CITY OF NAPOLEON, OHIO — DEPT. OF BUILDING & ZONING
255 W. Riverview Avenue, Napoleon, Ohio 43545 (419) 592-4010

Permit No. 669 Date July 19, 1983

Brief Description of Work Construct 2 stud walls , add one outlet strip above counter, install electric wall heater

EXISTING ROOM 30' x 26'

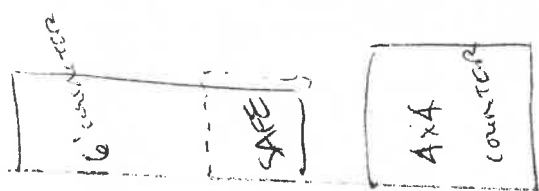
Walls shall be covered with 1/2" fire rated drywall
both sides
Heater receptacle shall be on separate circuit
